SERVICE INFORMATION LETTER NO. SIL20C1-005

DA20-C1 aircraft from S/N C0001 to C0571.

The improvement in the design of the Nose Landing Gear (NLG) Fork assembly. The old P/N 20-3220-08-00 has been replaced with the new NLG Fork assembly, P/N 20-3220-08-00_1.

Figure 1

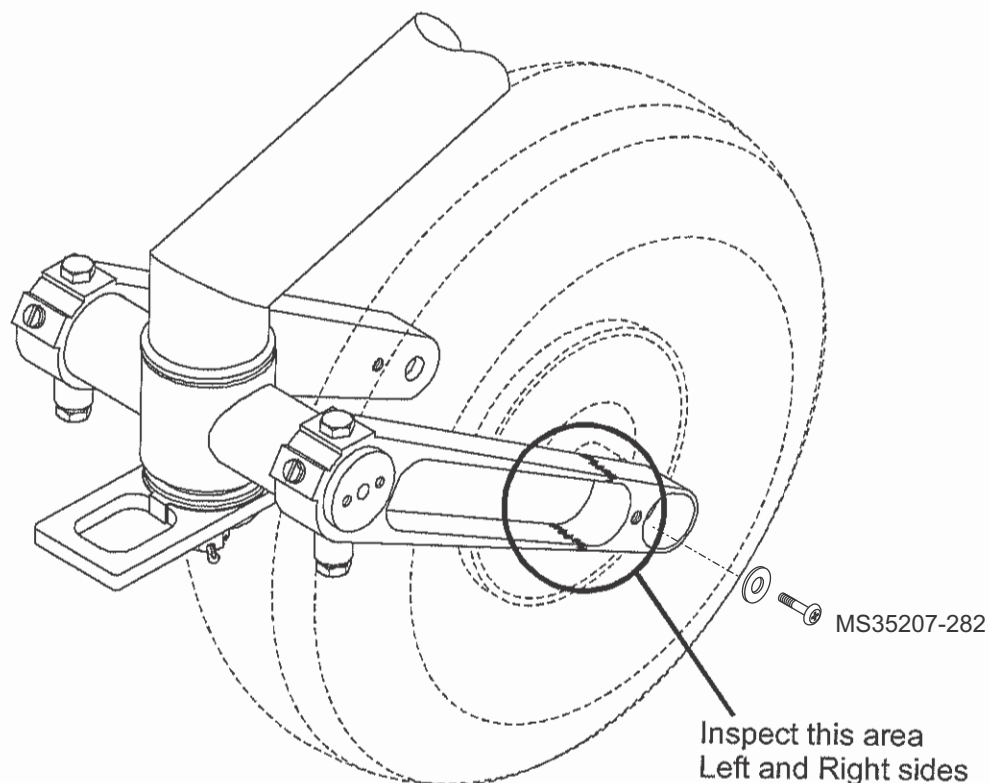
Cracks have been found on some NLG Fork assembly, P/N 20-3220-08-00 during routine inspections. Cracking usually occurs on higher time aircraft but could occur sooner with rough field operations or hard landings. Figure 1 shows where the cracking has normally occurred. Also, the machine screw, pan head, P/N MS35207-282 (see Figure 1) should be installed with Loctite 242 when the wheel fairings are not used to avoid any potential cracking that may occur at that location.
